IN THE DRAWINGS

REMARKS

Fig. 7

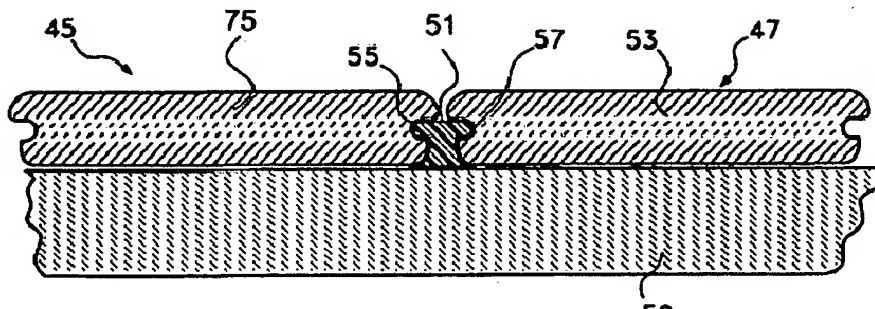
The Examiner has objected to the drawings entered on February 12, 2009, (i) disputing that Fig. 7 is an accurate cross-sectional view corresponding to what is shown in Figs. 1-3; and (ii) contending that it is unclear what material the cross-hatching of beams 45 and 47 represents, such that there is a question whether cross-sectional or end views are being shown.

Please replace Sheet 2/2 of the existing drawings with a replacement sheet bearing amended Figure 7, as well as Figures 5-6, and 8, which are not presently amended. For the sake of clarity, Figure 7 is amended to change the cross-hatching of support board 59.

For the sake of clarity, the specification has been amended in the Brief Description of the Drawings at pages 26-27 to clarify that Figs. 7 and 8 depict cross-sectional views. The Detailed Description of the Present Invention has been amended to further characterize Figs. 7 and 8. In particular, the paragraph beginning at page 31, line 14 has been amended to indicate that the cross-section presented in FIG. 7 is taken in a plane generally perpendicular to the long direction of horizontal beams (decking boards) 45 and 47 and generally parallel to the sides of joist beam 59. Accordingly, horizontal beams 45 and 47, joist beam 59, and anchoring device 51 are all depicted in cross-sectional view. Because beams 45 and 47 run generally perpendicular to joist 59 in a typical decking installation, the cross-section in Fig. 7 cuts beams 45 and 47 across end grain, while joist 59 is cut along side grain. Applicant respectfully notes that the terms “end grain” and “side grain” are understood with reference to decking systems in which the decking boards and joist are all made of ordinary wood. It is further noted that other materials are also suitable for the decking boards of the invention, e.g. materials selected from the group consisting of synthetic polymers, at least partially foamed synthetic polymer, wood, wood composite, and combinations thereof recited by

The specification description of Figs. 7-8 has also been amended to include reference to the upper portion 61 and the lower portion 63 of the sides of decking boards 45, as depicted by Fig. 8.

(GB 1,350,754, as annotated by the Examiner)

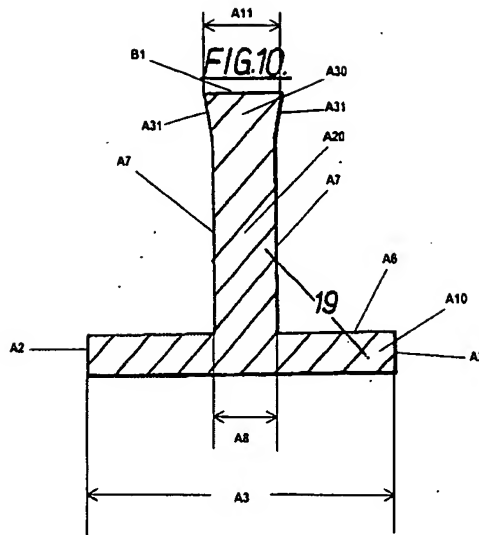
Regarding claim 29, the British patent discloses, in Figure 10, an anchoring device consisting essentially of a substantially flat horizontal top element A10, at least one substantially vertical support member A20, and a substantially flat horizontal bottom element A30. The top element A10 has a top view configuration including two sides A2 and a predetermined first width A3 as measured side to side. The first width A3 is measured at a maximum width between the sides A2. The top element A10 has an imaginary center line A4. The support member A20 is attached to an underside A6 of the top element A10 along the center line A4¹ and the support member A20 extends downwardly therefrom. The support member A20 has two sides A7 and a predetermined second width A8 as measured side to side at a maximum width. The bottom element A30 has a flat bottom view configuration, which includes sides A31 and having a generally trapezoidal shape, and a predetermined third width A11 as measured side to side at a maximum width at a trapezoidal base B1. The first width A3 is greater than the second width A8 and the third width A11. The third width A11 is greater than the second width A8. The device is made of molded plastic material (column 4, lines 72-84).

Applicant respectfully traverses the Examiner’s contention that the British patent discloses every structural feature of the anchoring device delineated by claim 29, as would be required for a proper rejection under 35 USC §102(b).

Applicant maintains that the foregoing functional limitations in fact positively recite further structural limitations that distinguish the anchoring device of claim 29 from any article disclosed or suggested by the British patent. There is no disclosure whatsoever in the British patent that "top"² element A10 is intended to be received into any groove of a tile or other article. To the contrary, the British patent universally teaches that element A10 is to be installed below the tiles and that the Fig. 10 strip is used with plain-edged tiles, whereas other configurations of grouting strips (e.g. strip 16 with interlocking, ear-like projections 16a) are to be used with grooved tiles. See, e.g., page 2, col. 1, lines 40-42 and Figs. 9-10; compare page 2, col. lines 28-32 and Figs. 4-6. Accordingly, applicant respectfully submits that a fair reading of the British patent contradicts the Examiner's proposition that width A8 of top element A10 is intended to be shaped and dimensioned so as to permit it to be received in a groove of any tile or other article. Significantly, Fig. 10, which the Examiner has cited, is said to be of a T-section strip appointed for use with a plain-edge tile, i.e., a tile lacking any edge groove or other like feature corresponding to the receiving slots delineated by claims 29 and 33. Page 2, col. 1, lines 11-13 and 40-43. Horizontal projections A2 of "top element" A10 are not received in any slot. Instead, element A10 is installed with its horizontal projection A2 underneath the back surface of each tile,

² Applicant reiterates that what the Examiner has annotated as element A10 is never called a top element in the British patent, and that element A10 is depicted as the bottom portion of the strip shown in Fig. 10. The "top" nomenclature is purely a designation bestowed by the Examiner. .

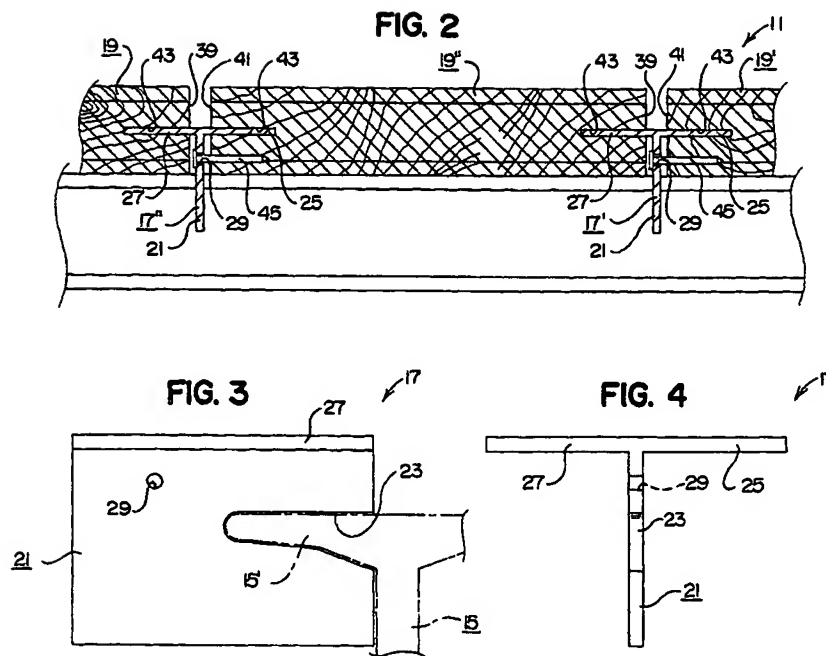
Regarding claim 29, Fisher et al. disclose, in Figure 3, an anchoring device comprising a substantially flat horizontal top element 14b, at least one substantially vertical support member 14c, and a substantially flat horizontal bottom element 14a. The top element 14b has a top view configuration including two sides A2 and a predetermined first width A3 as measured side to side. The first width A3 is measured at a maximum width between the sides A2. The top element 14b has an imaginary center line A4. The support member 14c is attached to an underside A6 of the top element 14b along the center line A4 and the support member 14c extends downwardly therefrom. The support member 14c has two sides A7 and a predetermined second width A8 as measured side to side at a maximum width. The bottom element 14a has a flat bottom view configuration which includes sides A10 and having a generally trapezoidal shape, and a predetermined third width A11 as measured side to side at a maximum width at a trapezoidal base B1. The first width A3 is greater than the second width AS and the third width A11. The third width A11 is greater than the second width A8.

The present Office Action refers to the marked-up version of Fig. 3 of Fisher et al. included in a previous Office Action. Significantly, that version of Fig. 3 is depicted in an orientation that has been inverted with respect to Fig. 3 as it was originally presented in Fisher et al. The original orientation of Fig. 3 places the largest width of beam 14 (denoted as A3 by the Examiner) on the bottom, corresponding to its disposition in the finished construction shown in Figs. 1 and 2. By way of contrast, and without notice, the Examiner has placed the largest width (i.e. the width of flange 14b) on the top of the altered drawing. Applicant maintains that "top" and "bottom" as used in both Fisher et al. and the instant specification are terms of ordinary language. They have not been imbued with any special technical meaning by applicant or by any of the prior art references applied, including Fisher et al. It is submitted that the Examiner's alteration is repugnant to ordinary meaning and thus impermissible, absent clear evidence to substantiate the change.

Applicant particularly traverses the Examiner's assertion that "The terms 'top' and 'bottom' are merely relative terms." (Office Action at 16.) The distinction between "top" and "bottom" is not a matter of mere semantics, because the "bottom" of Fisher et al.'s dissymmetric structural steel beam 14 is defined by the direction of gravity and the beam's function of supporting planks 12a, 12b. Likewise, the "top" and "bottom" of applicant's anchoring device are distinguished by manner in which decks are installed, with decking boards on "top" of support boards. The Examiner has repeatedly referred to Fig. 3 of Fisher et al., which he has modified by presenting it

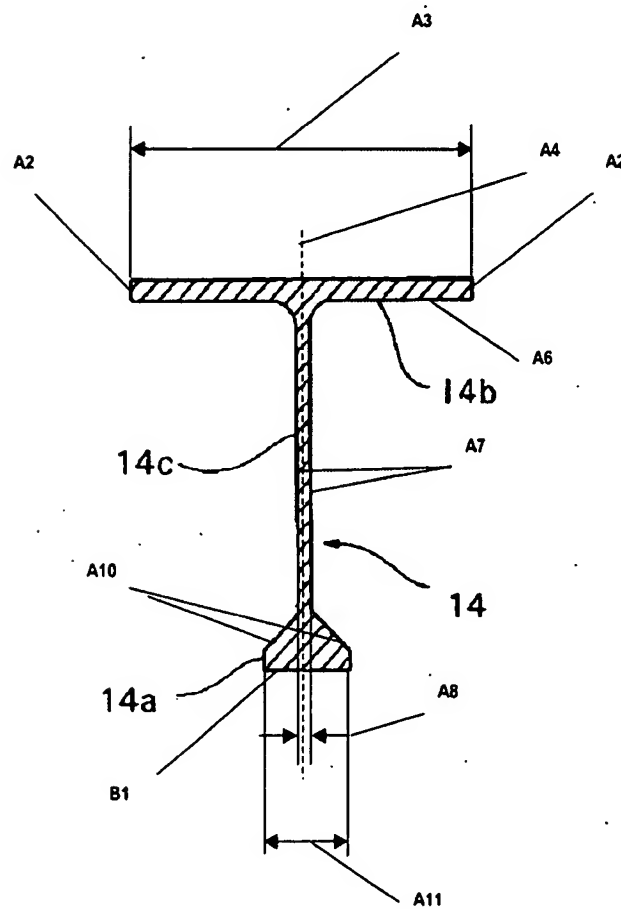
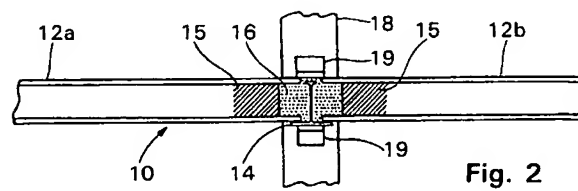
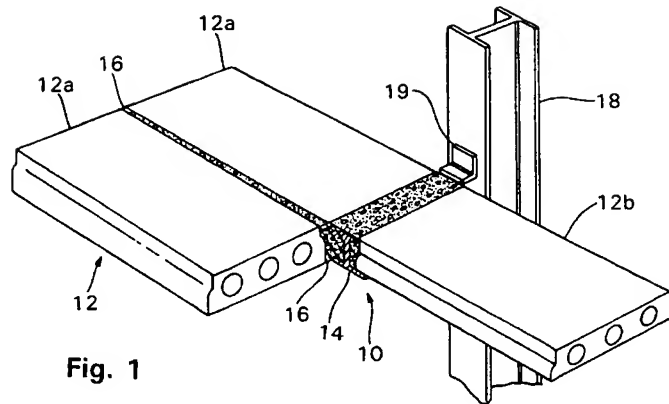
The Examiner has stated that Curtis, Jr., teaches in Figs. 2 and 4, a support column 17', 21 having recesses to allow the insertion of a fastener therethrough. He then asserts that it would have been obvious to include recesses on the vertical support member of Child to allow insertion of a fastener, thereby creating support columns between the recesses.

Applicant respectfully traverses the identification of items 17' and 21 of Curtis, Jr., as being, or even having, support columns. The Curtis specification calls items 17' and 21 a "fastening member" and a "vertical platelike body portion of a fastening member," respectively. *See* col. 2, lines 59 and 20. As seen in Fig. 3 of Curtis, there is a small hole 29 through the vertical portion of members 17 or 17'. Hole 29 is necessarily small to carry out its intended function, i.e., to permit a nail to be driven generally horizontally, through the fastener and into the adjacent decking board,

support. Rather, as depicted most clearly by Curtis's Fig. 3, the device 17 includes within its vertical portion 21 a generally horizontally directed slot 23 that engages the support (i.e., the top flange 15' of an I-beam 15). *See, e.g.*, col. 2, lines 19-35 generally.

(Naccarato et al., US Patent 6,442,908)

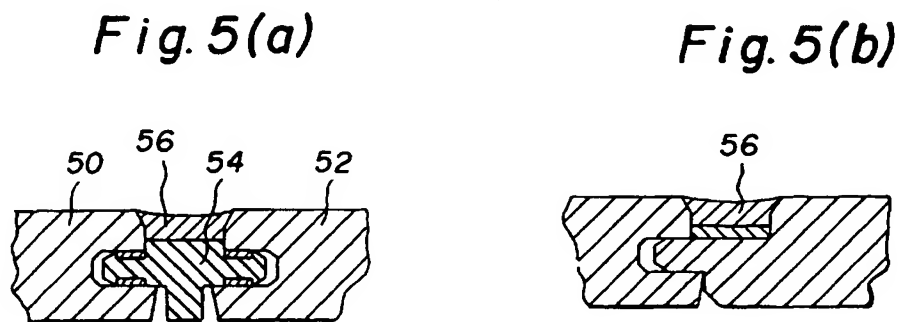
Regarding claim 30, Fisher et al., as modified above, fail [to] disclose the vertical support member 14c having recesses with support columns located therebetween. Naccarato et al. teach, in Figs. 4 and 5, a vertical support member 14c having recesses 15 to promote optimal flow of grout material through the support member (col. 5, lines 29-35). Therefore, as taught by Naccarato et al., it would have been obvious to one of ordinary skill in the art at the time the invention was made to include recesses in the vertical support member to promote optimal flow of grout material through the support member. Applicant is reminded that columns will be inherently located between the recesses as shown in Figure 3 of Naccarato et al.

It is respectfully submitted, for the reasons set forth above, that Naccarato et al. does not materially supplement the teaching of Fisher et al. At best, Naccarato et al. discloses perforation of the Fisher et al. dissymmetric steel beam, but it does not otherwise suggest changing its dimensions or basic functioning. The perforation would, if anything, require increasing the thickness of the remaining portions of the dissymmetric steel beam to compensate for material removed. The overall concrete and steel structures taught by the respective patents are virtually identical. Accordingly, it is submitted that even the addition of Naccarato et al. does not cure the lack of

(Chen et al., US Patent 6,363,677, as annotated by the Examiner)

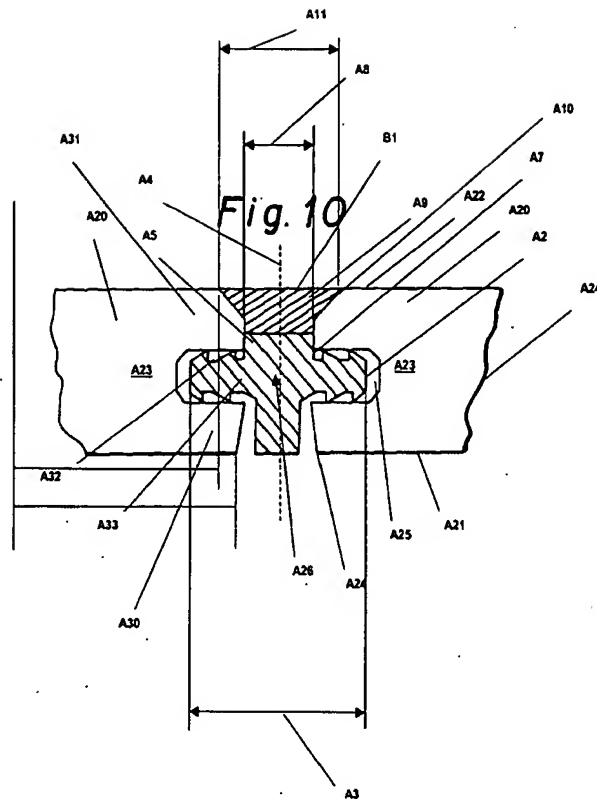
Regarding claim 33, Chen discloses in Figure 5³, a decking system comprising boards A20 and an anchoring device A26. Each of the boards A20 has a top A21, a bottom A22, two sides A23 and two ends A24. At least one groove A25 is located along one of the sides A23. The anchoring device A26 consists essentially of a substantially flat horizontal top element A1,⁴ at least one substantially vertical support member A5, and a substantially flat horizontal bottom element A9. The top element A1 has a top view configuration including two sides A2 and a predetermined first width A3 as measured side to side. The first width A3 is measured at a maximum width between the sides A2. The top element A1 has an imaginary center line A4. The support member A5 is attached to an underside A6 of the top element A1 along the center line A4 and the support member A5 extends downwardly therefrom. The support member A5 has two sides A7 and a predetermined second width A8 as measured side to side at a maximum width. The bottom element A9 has a flat bottom view configuration, which includes sides A10, and having a generally trapezoidal shape, and a predetermined third

³ *Sic* – the Examiner’s annotations, including reference number designations, were made with specific reference to Fig. 10, not Fig. 5.

⁴ *Sic* – the reference designation of A1 does not appear in Fig. 10, as annotated by the Examiner.

The confusion arising from the Examiner's inversion of the supposed Chen anchoring device is even further compounded by the Examiner's characterization of the sides A2 as defining a width A3 of what he purports to be the top element A1 [*sic*]. On the other hand, claim 33 calls for an anchoring device having a "substantially flat horizontal top element having a top view configuration which includes two sides..." (emphasis added). Applicant respectfully submits that the allegedly anticipatory structure does not have the substantially flat horizontal top view configuration delineated by claim 33. Instead, the portion of element 54 that extends downward from the projections received in board grooves A25 in the depiction of annotated Fig. 10 (the "top" of the Chen et al. structure as apparently understood by the Examiner⁵) precludes the Examiner's conclusion, because it establishes a surface of element "A1" that is not substantially flat horizontally.
